SF2017/281844; WST17/00198/04

SSD-8895: Lots 75-84, 88, 119-121 DP 2987, Lots 1&2 DP 1104720, Lot 3 DP 976701, Lots 1-3 DP 808748, Lot 100 DP 750760, Lot 1 DP 1206579 and Lot 1 DP 664645 Goolma Road (MR633), Wellington; Wellington North Solar Farm; Amendment Report

Figure A 28: Basic right (BAR) turn treatment on a two-lane rural road

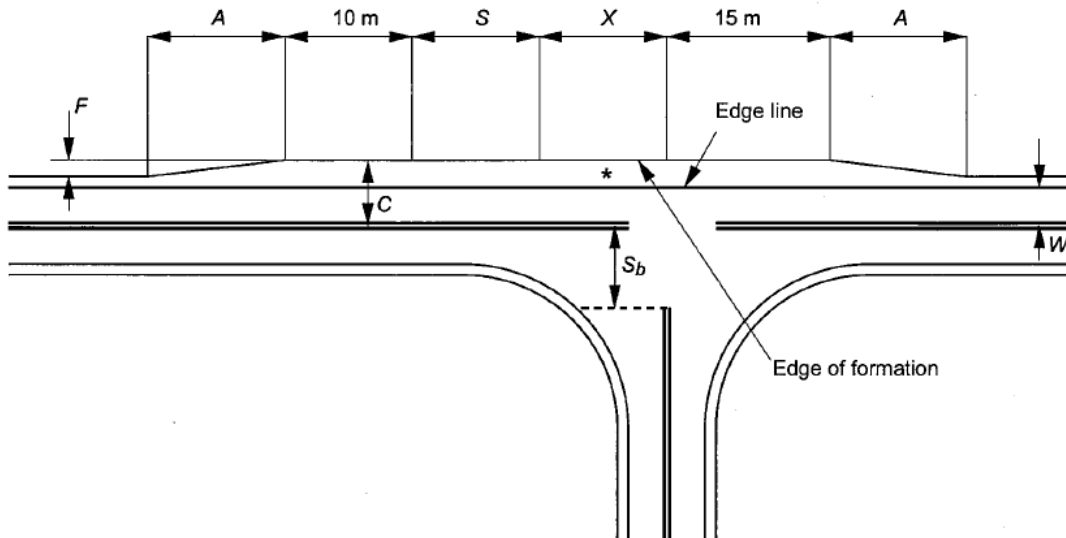
- A Basic Right (BAR) turn treatment as shown in Figure A 28 in *Austrroads Guide to Road Design Part 4 2017* (copy enclosed) and relevant Roads and Maritime supplements to *Austrroads*.

Figure 8.2: Rural basic left-turn treatment (BAL)

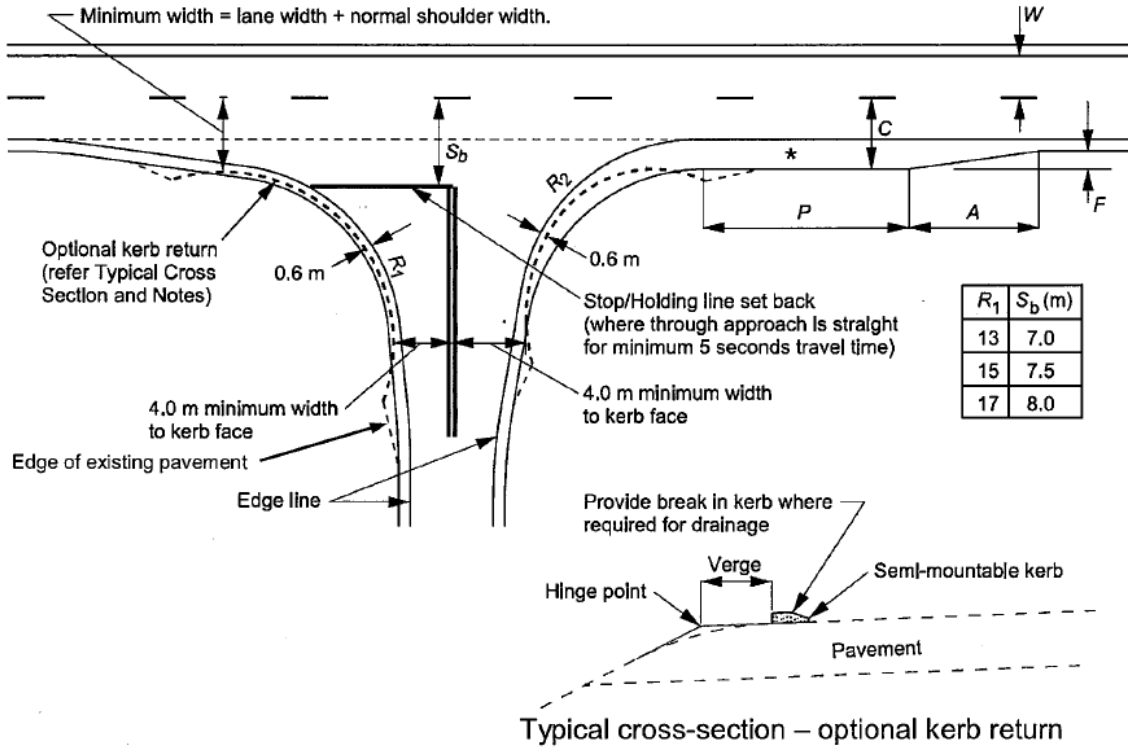
- A Basic Left (BAL) turn treatment as shown in Figure 8.2 in *Austrroads Guide to Road Design Part 4 2017* (copy enclosed) and relevant Roads and Maritime supplements to *Austrroads*.
